Project Memorandum

To:	KGHM Ajax Mining Inc.	Doc. No.:	BGC-007
Attention:	Nettie Ore	cc:	
From:	Cassandra Koenig	Date:	April 22, 2016
Subject:	Ajax Project EA/EIS - Responses to Information Requests from ECCC on Post-Closure Net Groundwater Flux		
Project No.:	1125011

2.1. Information Requirement Issue ID # ECCC-019

PROJECT:	AJAX PROJECT ENVIRONMENTAL ASSESSMENT NUMERICAL GROUNDWATER FLOW MODEL	
TITLE:	SIMULATED NET GROUNDWATER FLUX (POST-CLOSURE)	
PROJECT No.:	1125007-04	DWG No.: 01

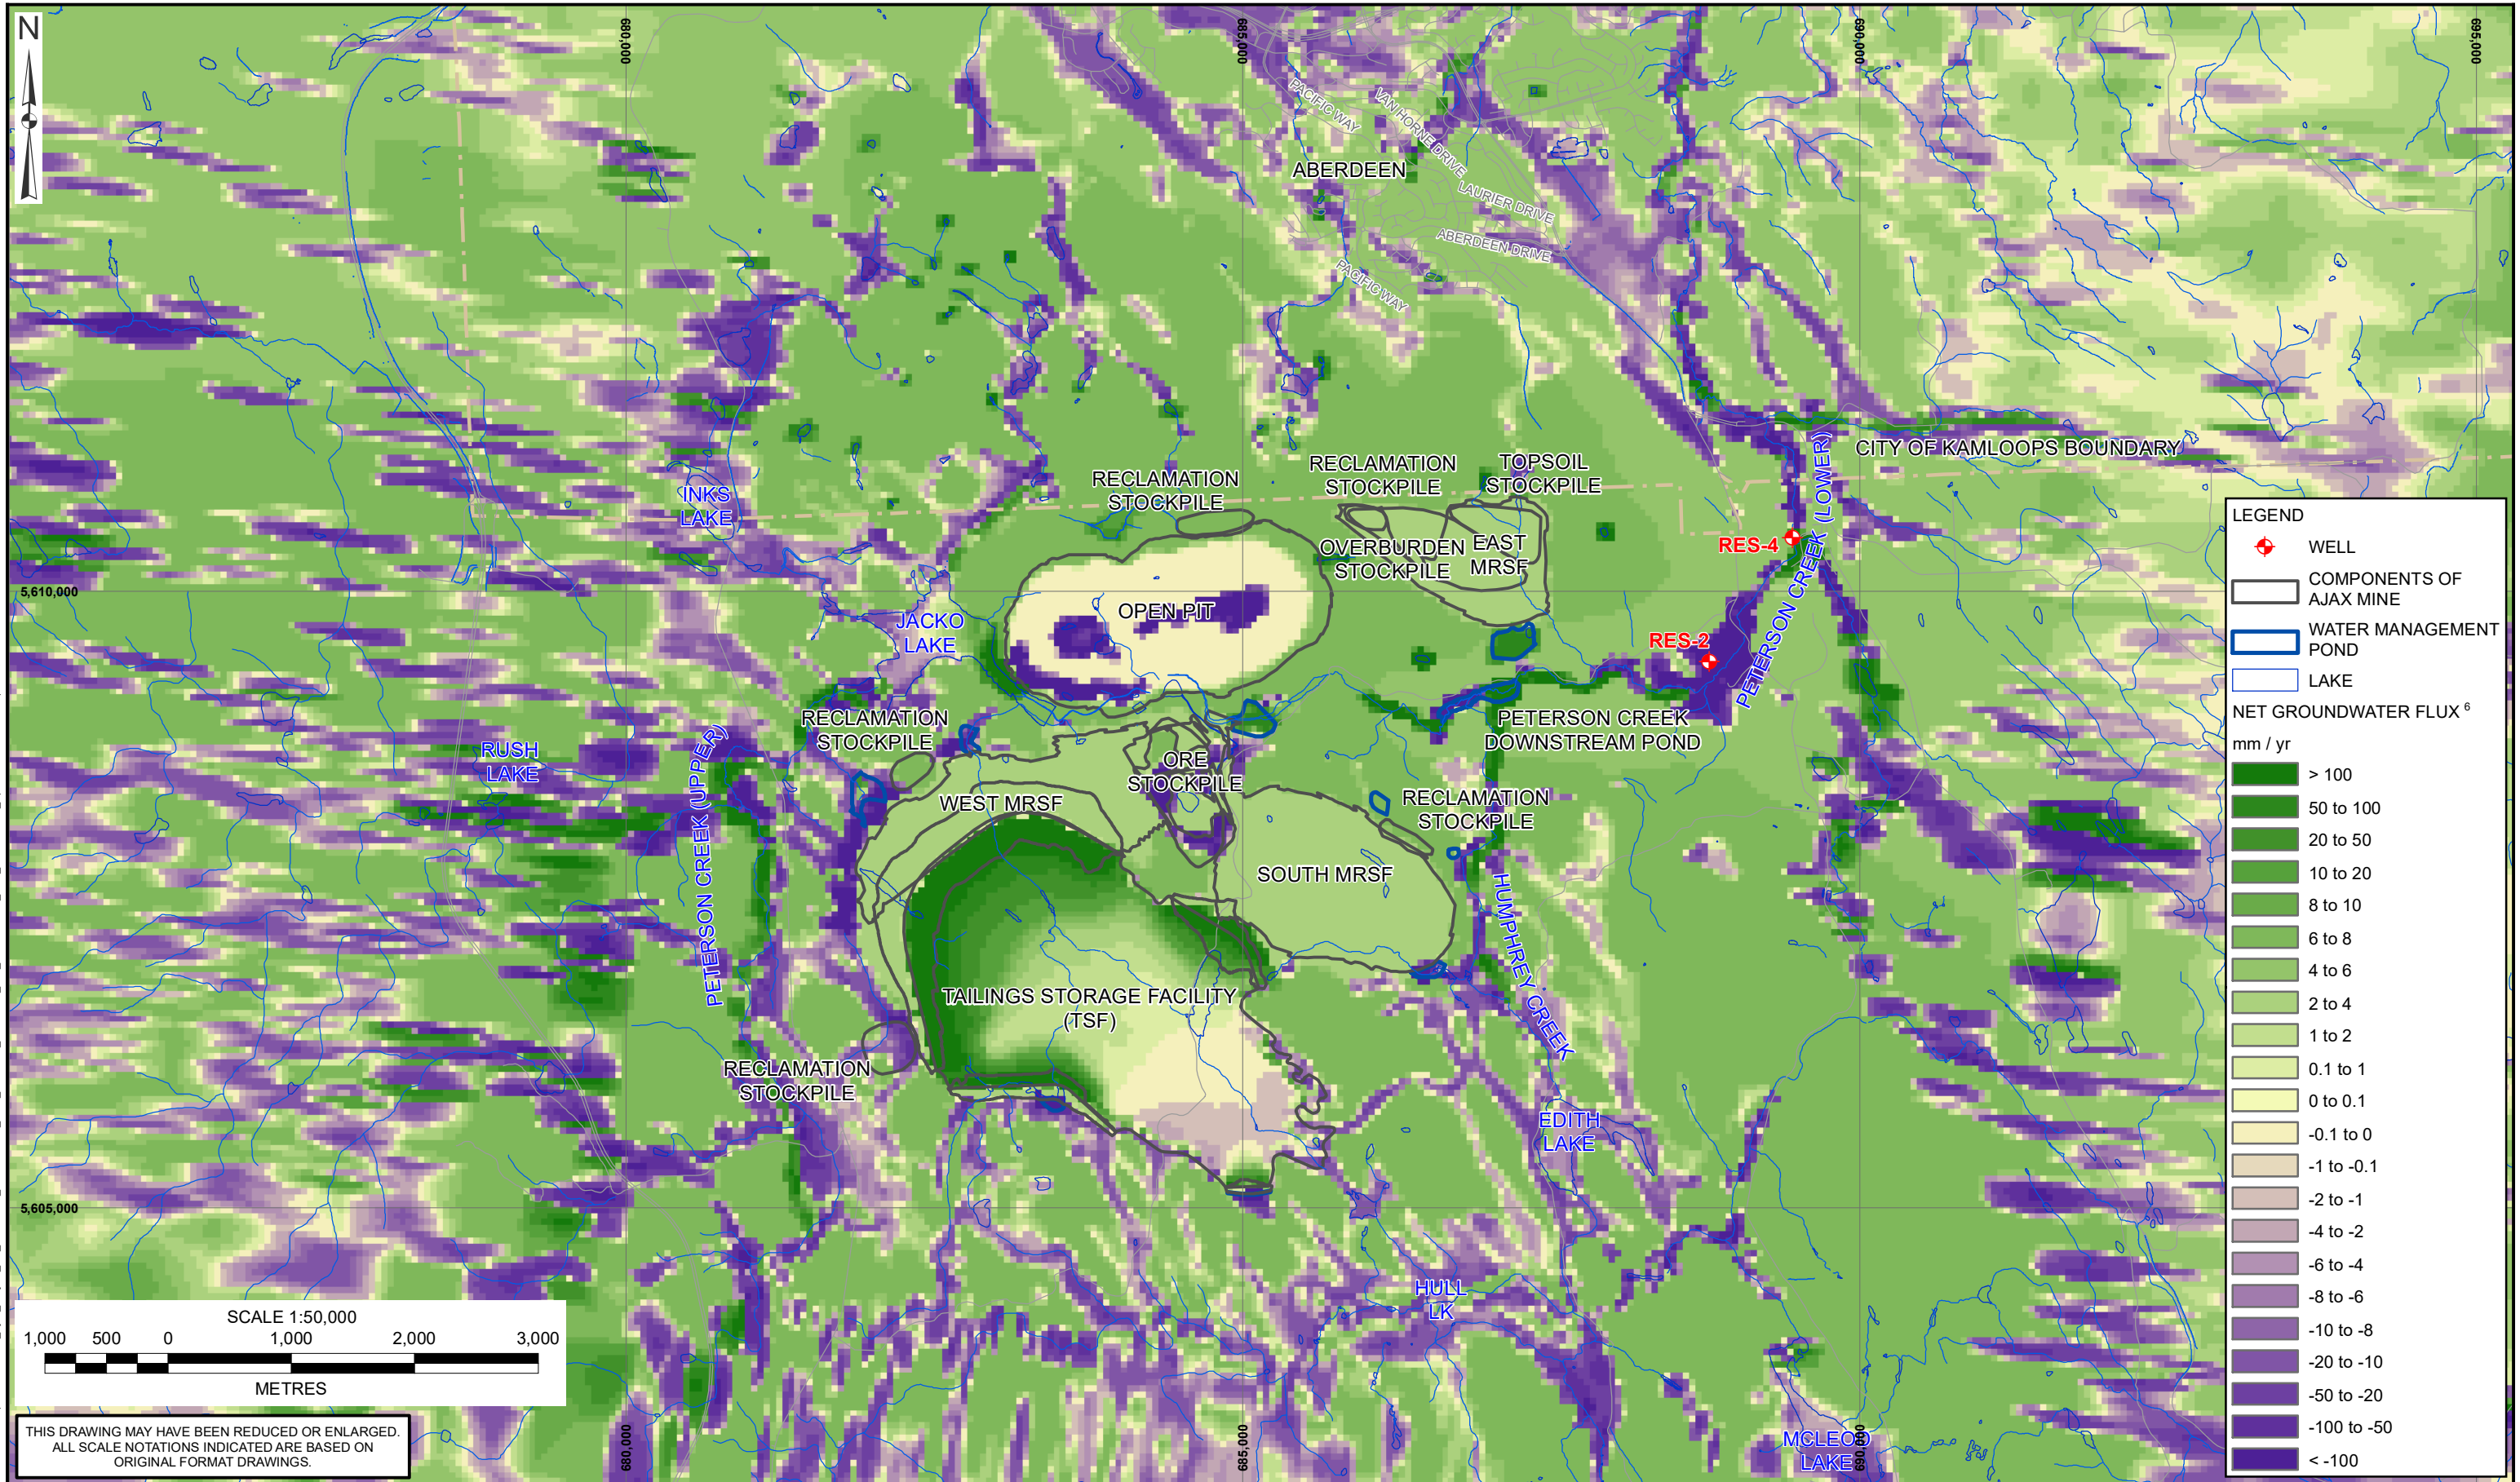
This net groundwater flux figure [Figure 6.6-14] doesn't show a high discharge flux rate (e.g., purple) for the open pit as expected from the text. MRSFs are light green, as expected from text description. TSF shows dark green in area of north embankment. This high groundwater recharge flux is not expected based on the description in the text. Resolve or explain the groundwater flux presented in the figure compared to the description in the text.

Discharge to the open pit is predicted to occur at a low to negligible rate throughout most of the pit footprint as shown in Figure 6.6-14 of the EA/EIS Application due to reduced groundwater levels around the pit and the generally low hydraulic conductivity of the bedrock. Zones of higher discharge are restricted to the footprint of the simulated pit lake (i.e., simulated stage of 500 masl) and along the southwestern pit wall. The reviewer is correct that these zones did not get incorporated into Figure 6.6-14 of the EA/EIS. This figure has been updated and is included here as Drawing 01.

Seepage from the TSF is predicted to vary across its footprint in response to hydraulic gradients. Higher seepage rates (and thus darker green colors) are predicted adjacent to embankments

where larger hydraulic gradients are present due to the presence of the low hydraulic conductivity embankment liner simulated using the horizontal flow barrier package (Section 6.4.7, Appendix 6.6-D). Lower seepage rates (i.e., approaching zero) are predicted in the central portion of the TSF where lower hydraulic gradients are predicted.
